CIRCUITRON CORPORATION SUPERFUND SITE  
EAST FARMINGDALE, NEW YORK

Report of the Streamlined Remediation System Evaluation,  
Conference Call Conducted  
August 12, 2004

EPA 542-R-05-004  
January 2005  
[www.epa.gov/tio](http://www.epa.gov/tio)  
[clu-in.org/optimization](http://clu-in.org/optimization)

**Streamlined Remediation System Evaluation (RSE-Lite)  
Circuitron Corporation Superfund Site  
East Farmingdale, New York**

**FIGURE 1-1. SITE MAP AND WELL LOCATIONS**

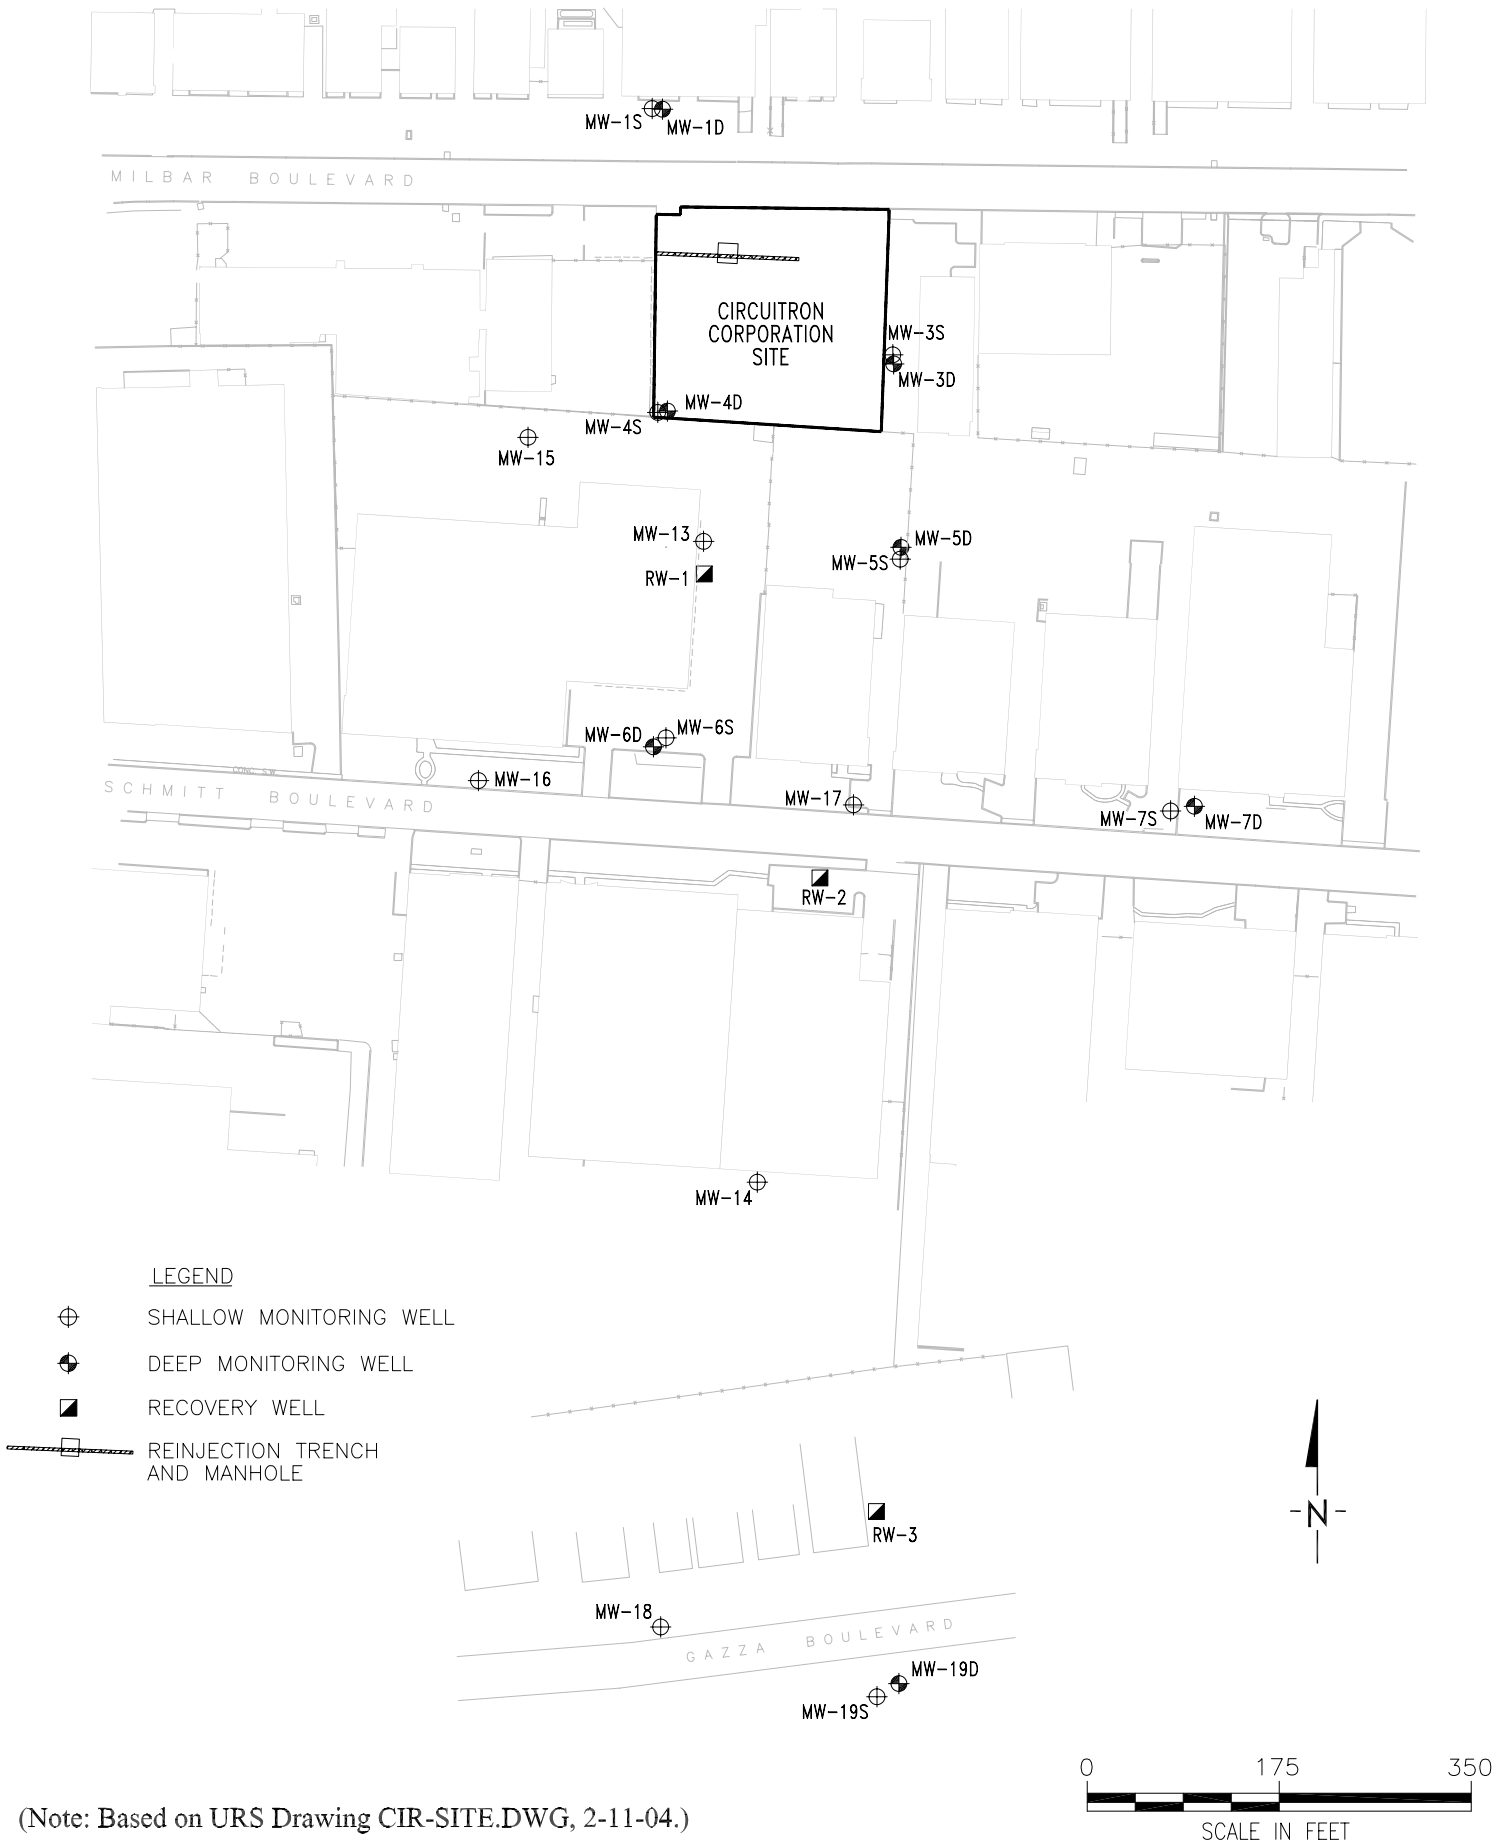
The ground water extraction system consists of three extraction wells (RW-1, RW-2, and RW-3) each equipped with a submersible pump and piping that discharges ground water to an on-site treatment plant. The extraction well locations are presented on Figure 1-1:

Based on the distribution of VOCs in monitoring wells, it is likely that the vast majority of influent VOCs are produced by RW-1. It is possible that both RW-2 and RW-3 are producing water below the ground water cleanup criteria for VOCs.

Ground water has not been sampled at the individual extraction wells. However, based on the system influent concentrations and the recovery well locations, it is very likely that RW-2 and RW-3 are pumping water at concentrations below cleanup goals. Sampling should be conducted to verify this hypothesis (estimated one-time cost of approximately \$2,000). If impacts at either of these wells is sufficiently low in the opinion of the site team (presumably at or near cleanup levels for all constituents), the site team should consider eliminating pumping either or both of these wells. The site team has indicated that there are no nearby receptors of immediate concern, the threat of continued contaminant migration beyond these wells is minimal, and the amount of mass being recovered by these wells is likely negligible. This reduced flow rate in the treatment plant will reduce load on the bag filters and the drainage problems at the reinjection trench, which ultimately will reduce costs. Electrical costs will also be reduced. Specific cost reductions from this recommendation are quantified as part of other recommendations (6.2.3 and 6.2.4). These wells could subsequently be added to the monitoring program after shutdown, but existing monitoring wells likely provide sufficient spatial coverage.

FIGURE 1-2. TOTAL VOCs, SHALLOW WELLS, APRIL 2003

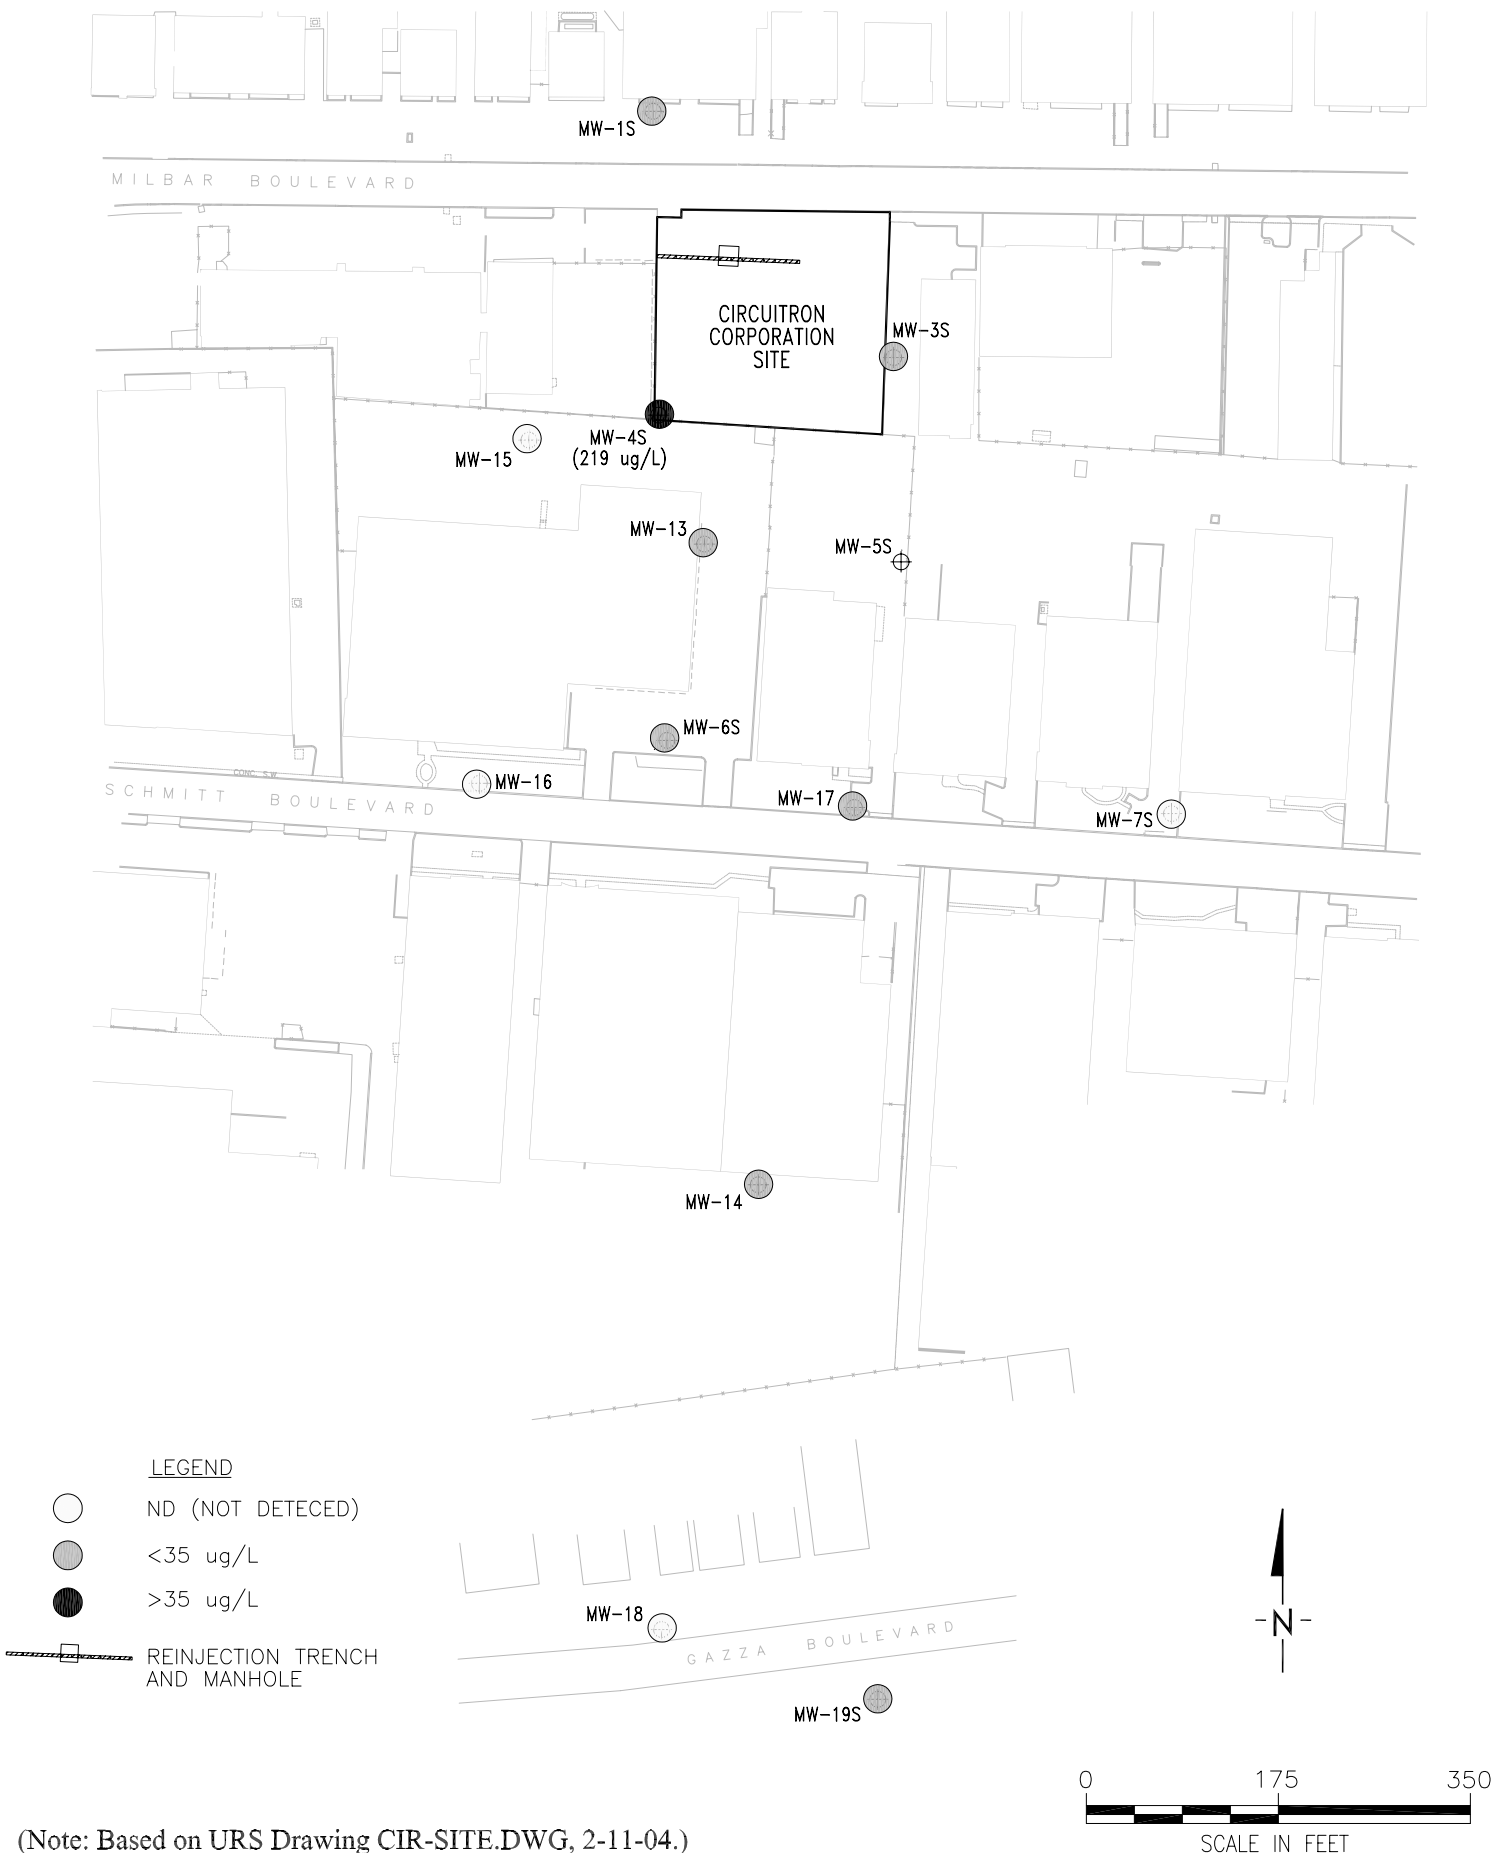
These data indicate that, in the shallow aquifer, VOC impacts are limited to just a few constituents with relatively low concentrations, with the exception of well MW-4S which has a moderate concentration of 1,1,1,-TCA of 190 ug/L. Similarly, in the deep aquifer, VOC impacts are limited to just a few constituents at concentrations only slightly above cleanup levels at a few wells (note that MW-19D, the furthest downgradient well, has the highest concentrations but those concentration levels are still not very high). URS suggests in the 2003 Annual Performance Monitoring Report that most or all of the impacts at MW-19D likely originate at a source upgradient of the subject property, and this interpretation was generally supported by the site regulators during the RSE-Lite call. The RSE-Lite team agrees that, based on information we have reviewed, it is likely that some of the impacts at MW-19D are not site-related.
